Spartan Fire, LLC

Technical Service Bulletin TSB23-520-001

APPLIES TO: This service bulletin applies to 2021 through 2023 model year, Gladiator, Metro Star, and FC-94 emergency response chassis cabs built between April 8, 2022 and September 26, 2022.

CONDITION: 120V box with dual breakers could be wired incorrectly.

Figure 2.1

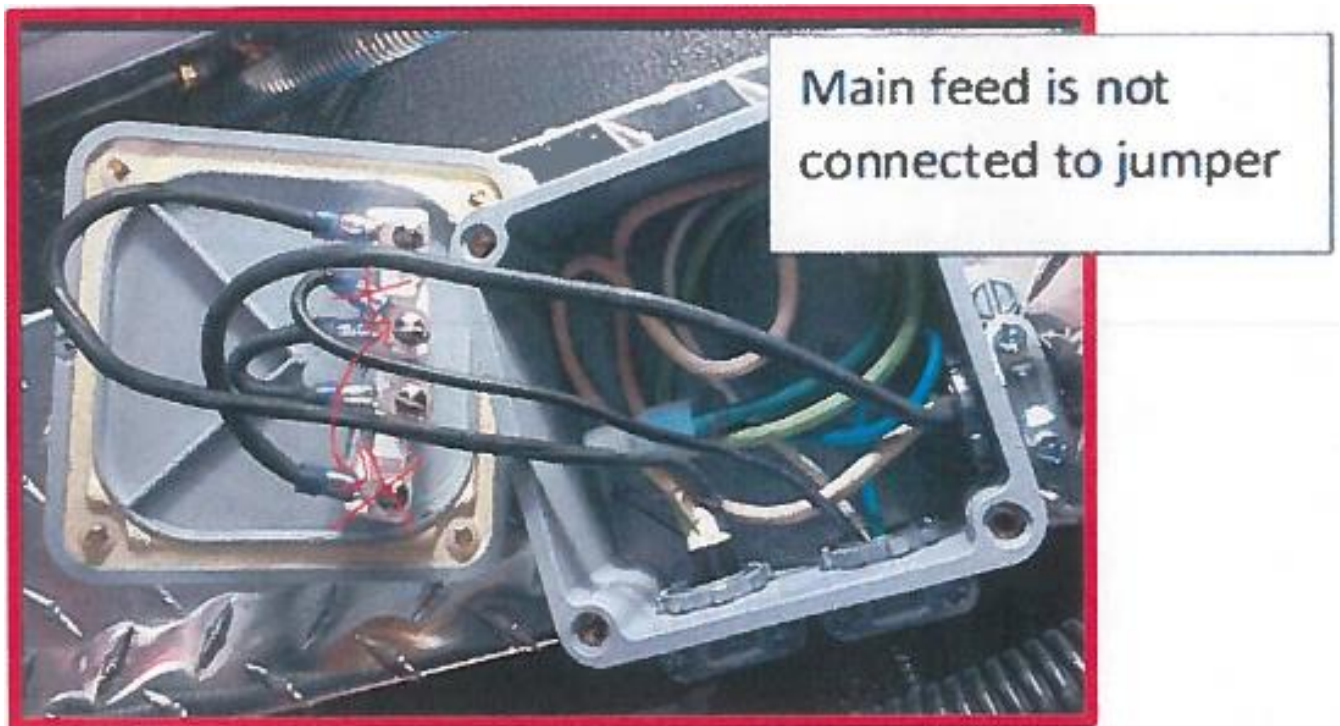
Main Feed Load Line (black wire) coming into box may not be wired correctly to the circuit breakers. If the black wire coming into the box is wired to the outside terminal of the circuit breaker and then the jumper between the circuit breakers is connected to the inner terminals, then the circuit breakers are wired in series, which is incorrect.
